Neasa Hourigan TD  
Leinster House, Kildare Street  
Dublin 2

An Bord Pleanála,  
64 Marlborough Street,  
Dublin 1, D01 V902

Re: PL29N.312298 77-80, King Street North, Smithfield, Dublin 7. D07 TP22  
(3617/21)

Figure 1

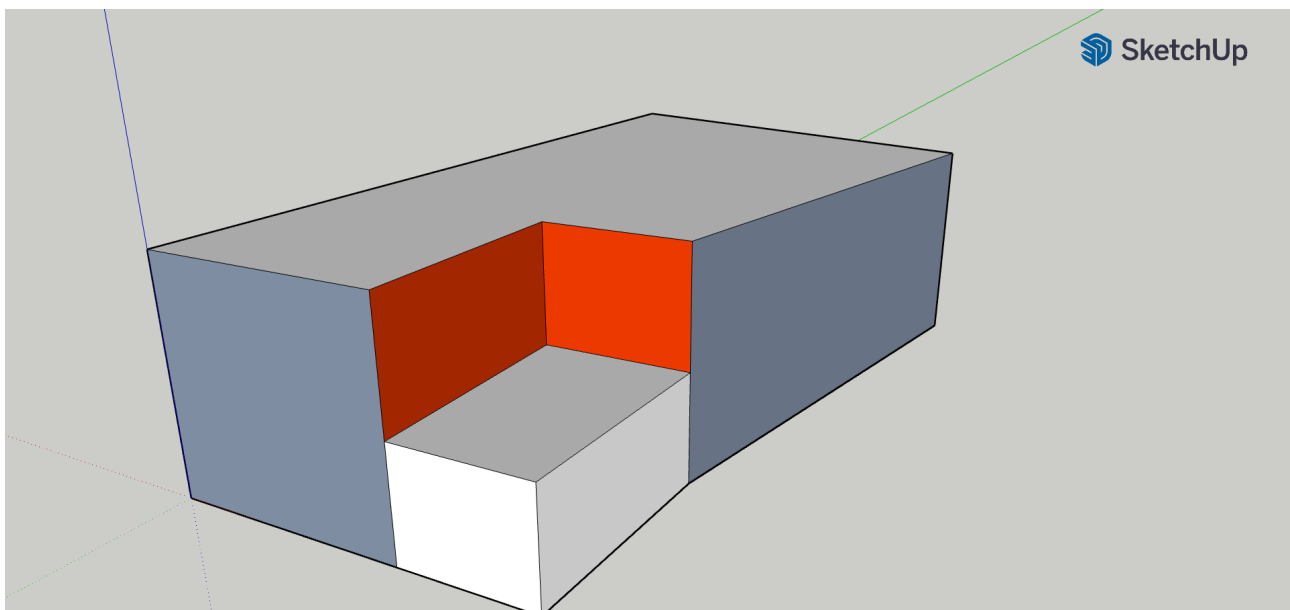
Without any 3D renders or plans for floors that overlook the Cobblestone building it is difficult to say that the new design will not be *“overbearing, excessive and out of scale and character with the prevailing architectural context”*. No details on the treatment of the facades (in red in Figure 1 below) overlooking the Cobblestone have been provided. It appears that there will be no step back of the hotel from the protected structure as has been done in similar developments (e.g. the hotel built adjacent to Fallons on The Coombe)
